Response to the requests for review to the request for registration of the “Sichuan Carbide Calcium Residues Based Cement Plant Project in Leshan City” (Ref. 2134),

2. result of the NPV analysis in baseline identification

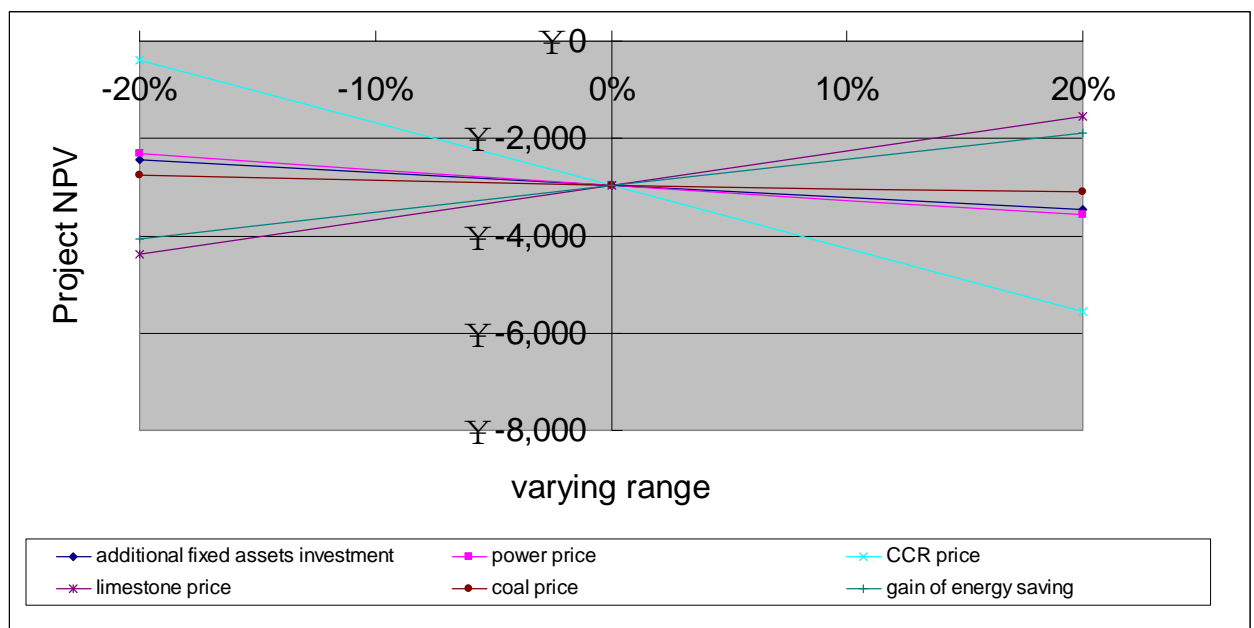
The PP/DOE shall explain why the calculation of financial costs (e.g. capital and variable costs) and account cost savings due to net energy gains, if any, from the project activity is not included for the selection of the baseline scenario as stated in AM0033 methodology (page 2).

According to calculation based on the above data, without CERs sales revenues, the NPV is -29.7 million RMB, thus the Project is not profitable.

Besides, in sensitivity analysis processes, while following financial parameters vary with a reasonable range (-20% to 20%), the NPV of the Project is always negative.
